**SOLICITATION E0208-150548/A - AMENDMENT No. 5 APPLYING ADDENDUM No. 3**

Public Works and Government Services Canada	Swift Current, SK AAFC Semiarid Prairie Agricultural Research Centre (SPARC) Rehabilitation	Addendum No. 3 Page 1 of 12
Project No.: R.036324.001		January 22, 2015

**ADDENDUM NO. 03**

**M503-R1**

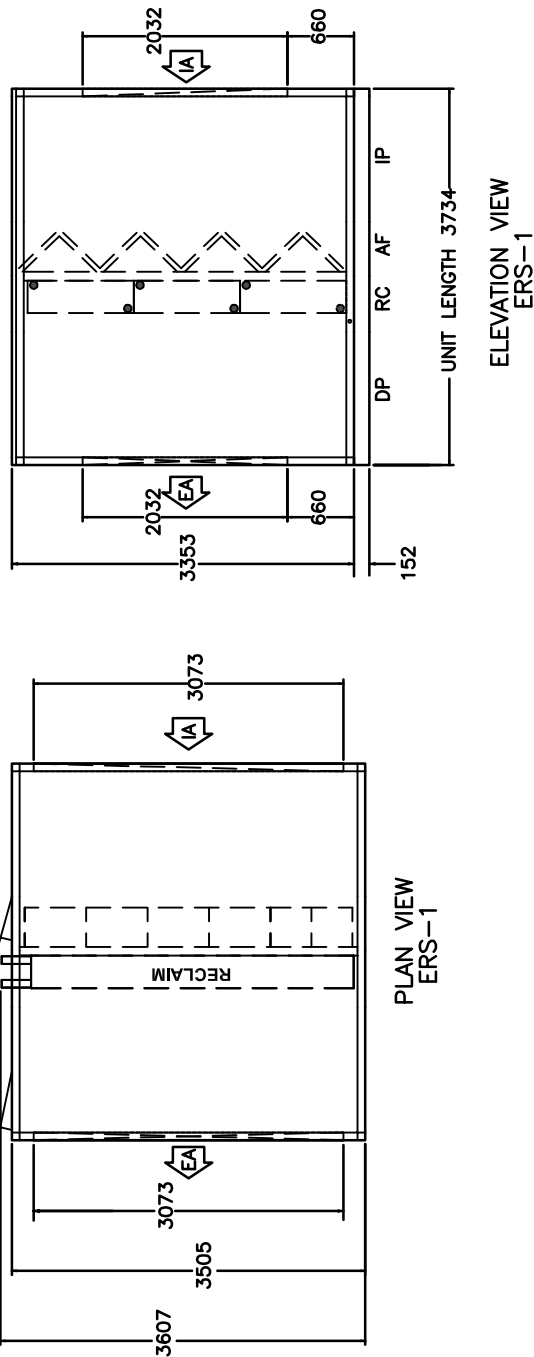
- .1 Add detail 9 – Exhaust Fans – LAB-1 & LAB-2 as per attached drawing M503R1.
- .2 Add detail 10 – Glycol Reclaim Coil Module – ERS-1 as per attached drawing M503R2.

**M704-R2**

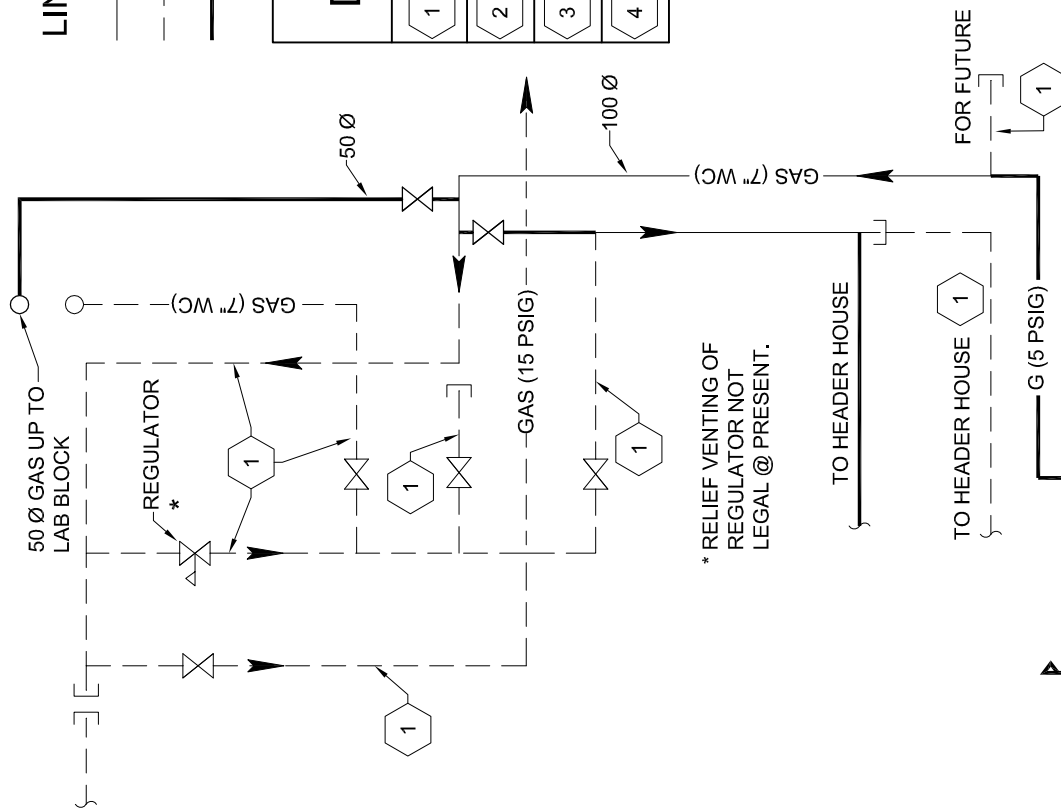
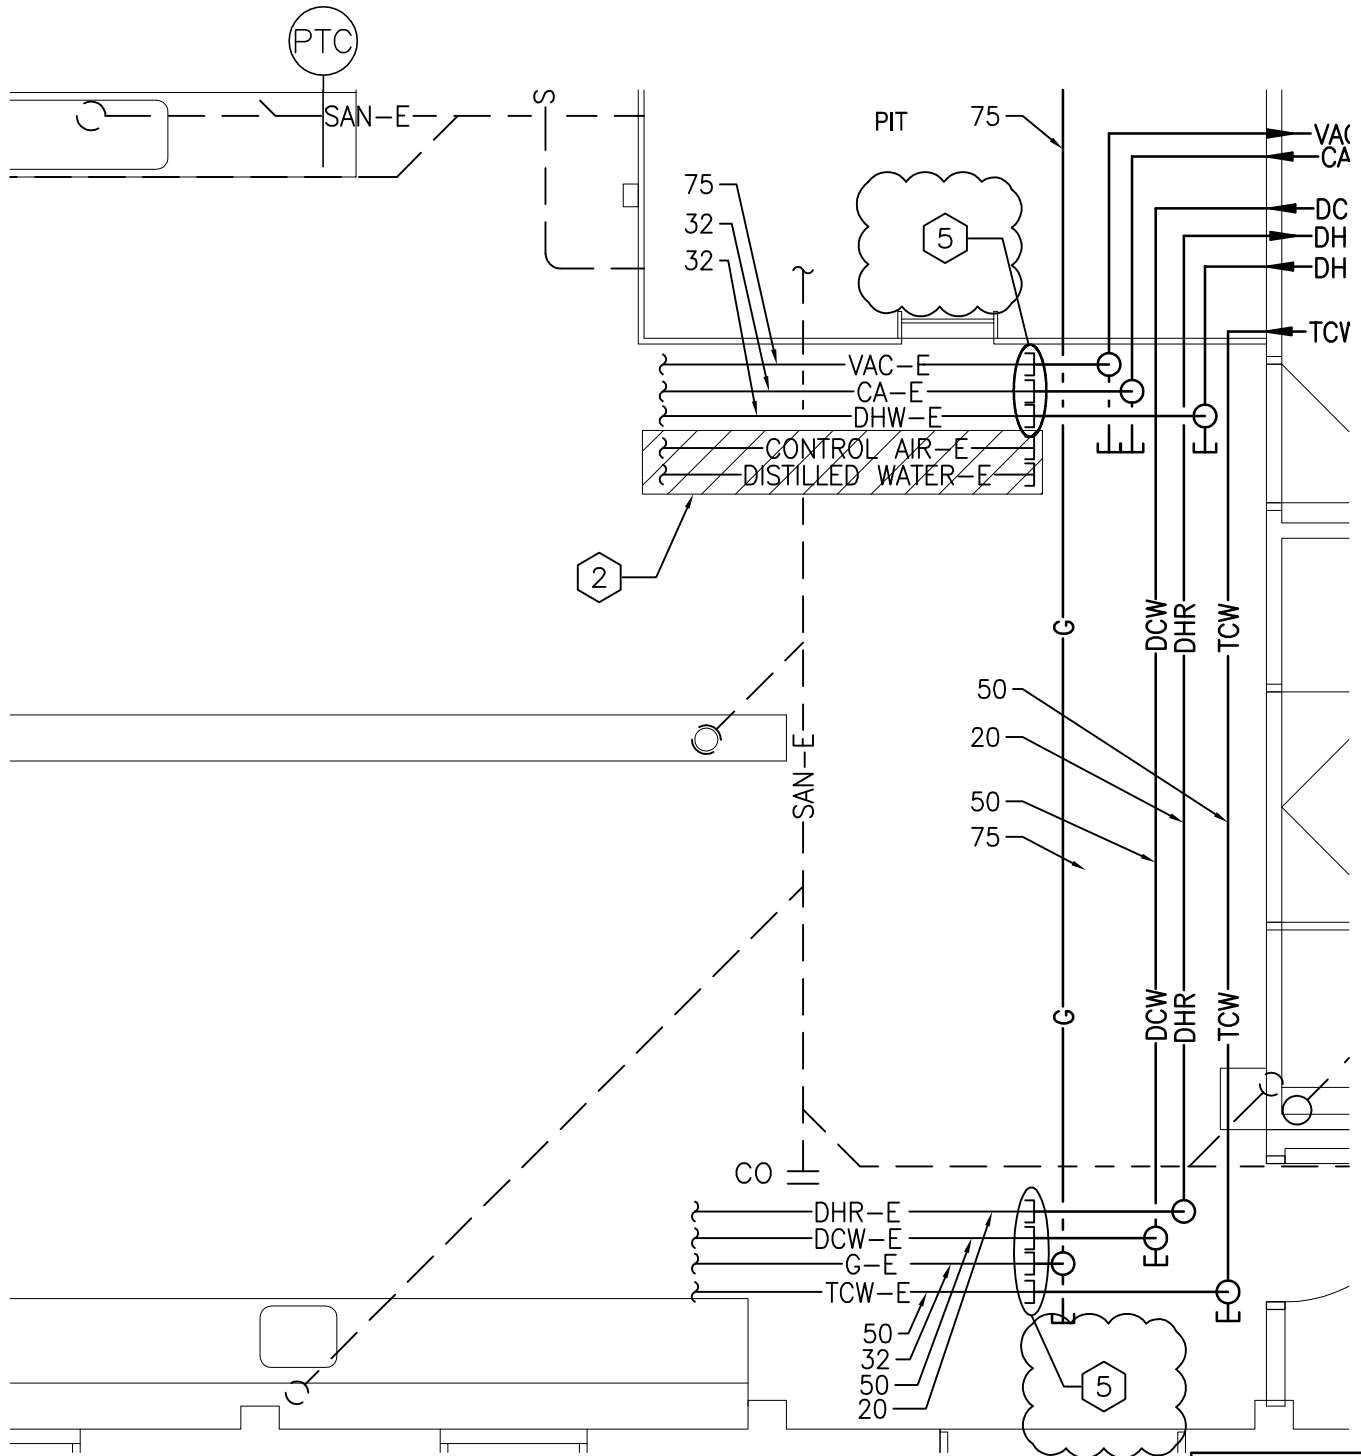
- .1 Add new natural gas schematic diagram showing existing, interim and final natural gas routing as shown on revision sheets M704R1 and M704R2.

**MP101R1**

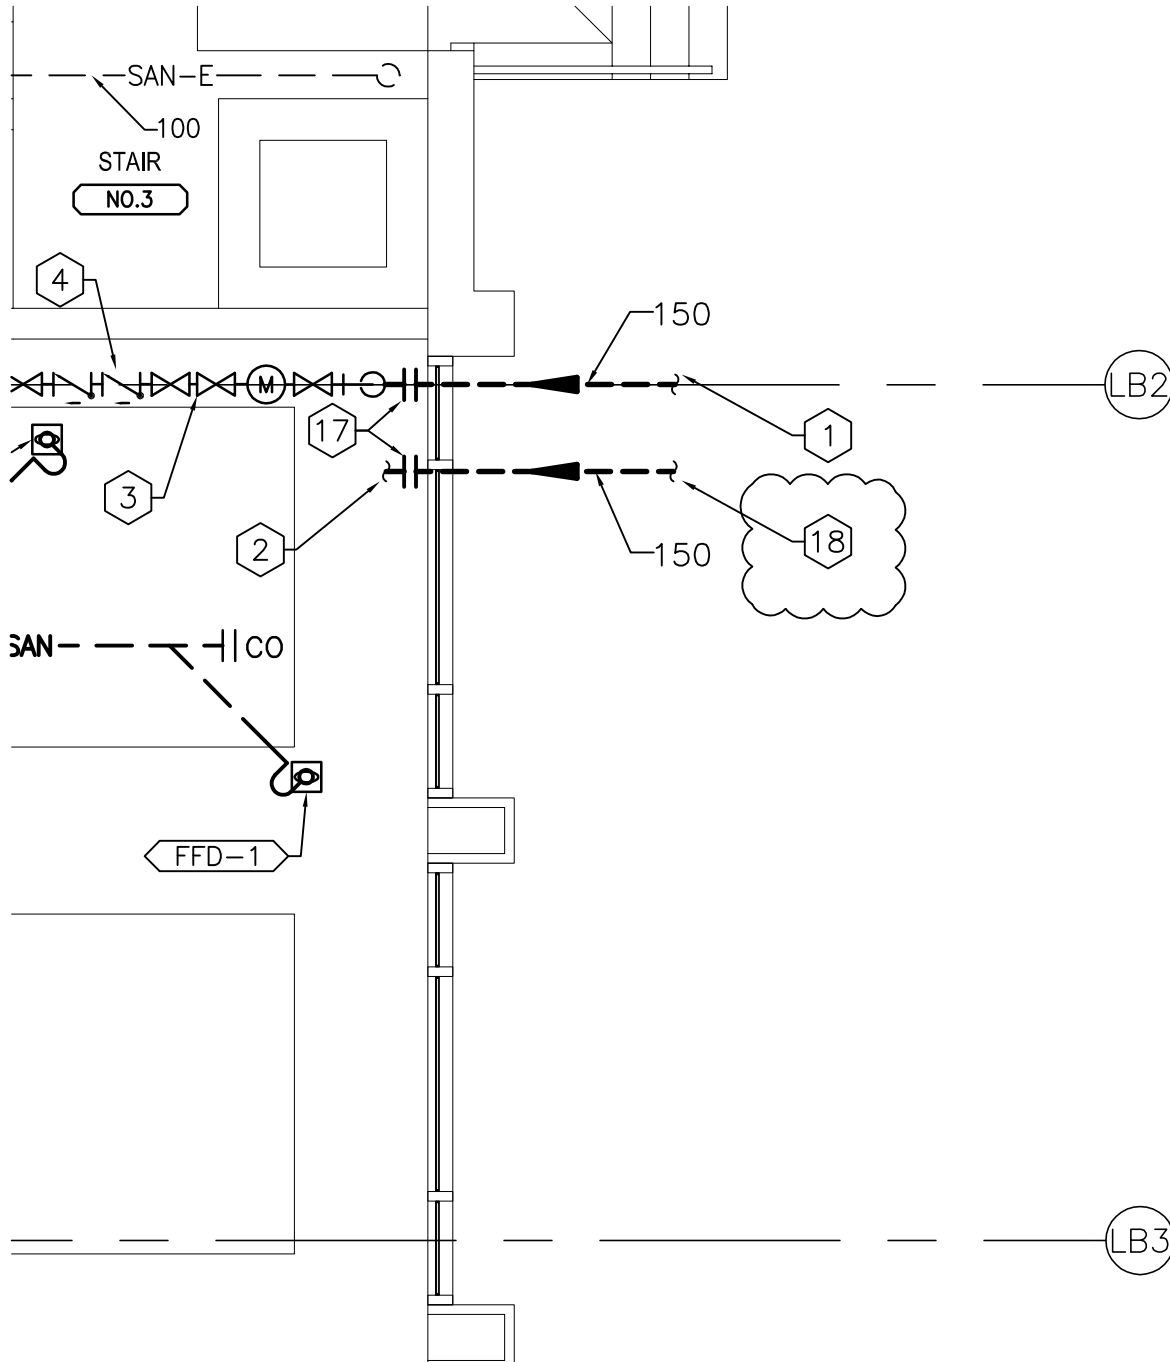
- .1 Revise keynote flag from 2 to 5 where indicated on attached revision sheet MP101R1.

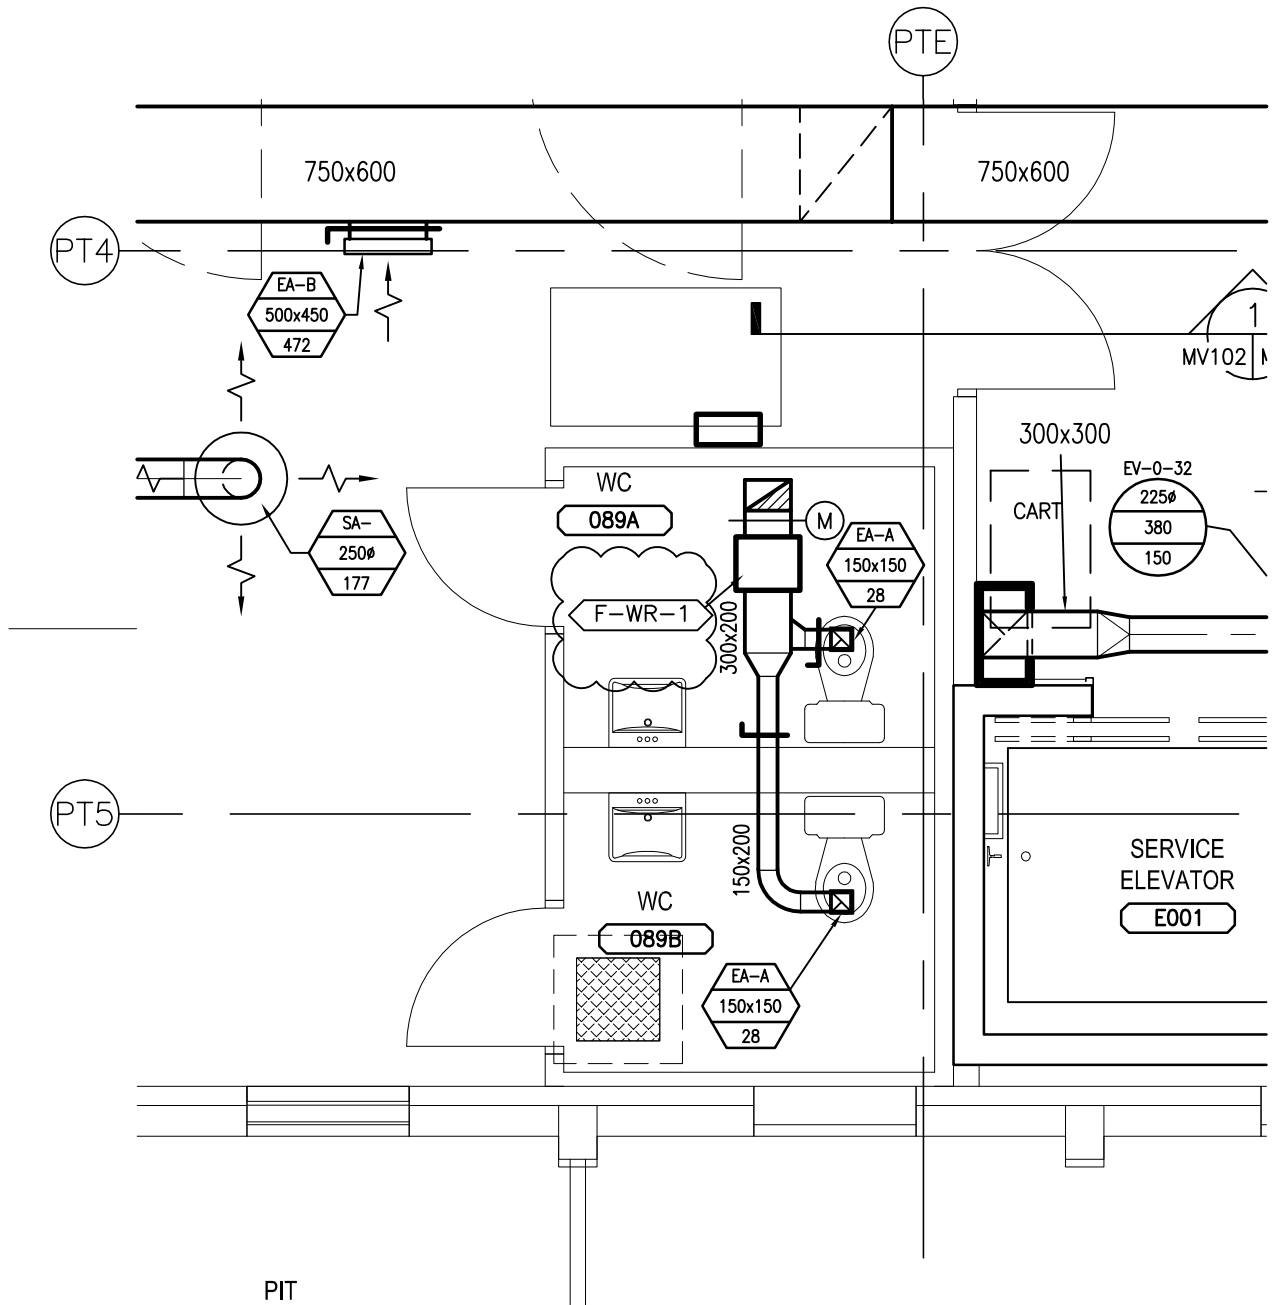
- .1 Add general note "All floor drains are to be FD-1 unless otherwise indicated."
- .2 Add keynote flag 18 where indicated on attached revision sheet MP103R1.

**MV101R1**

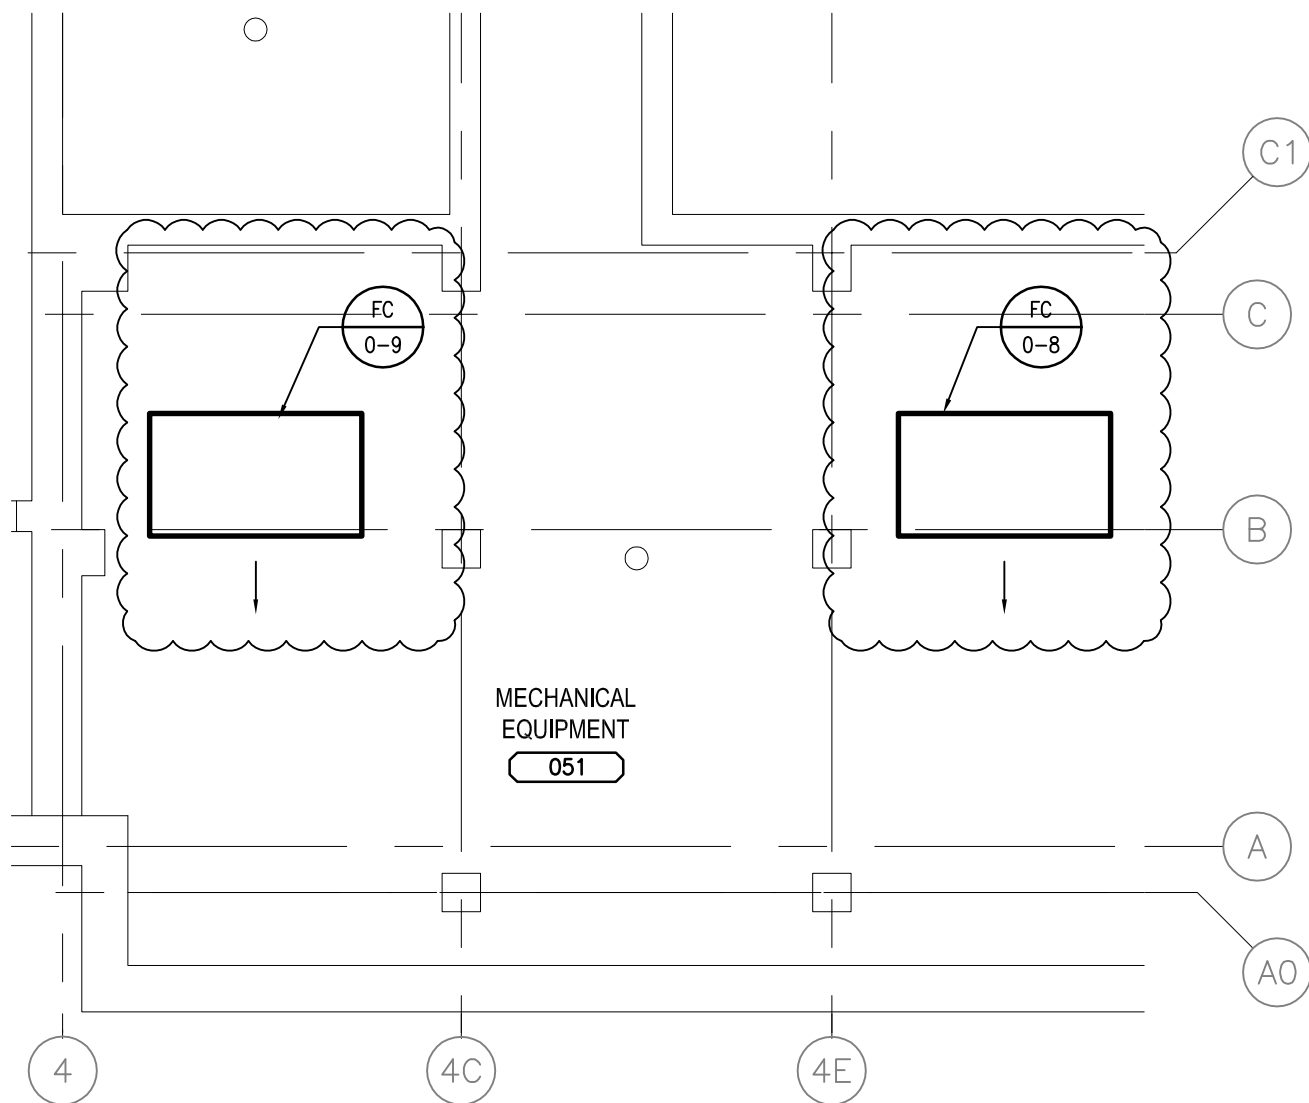
- .1 The exhaust fan located in WC 089A is to be tagged as F-WR-1. Refer to the attached revision sheet MV101R1.
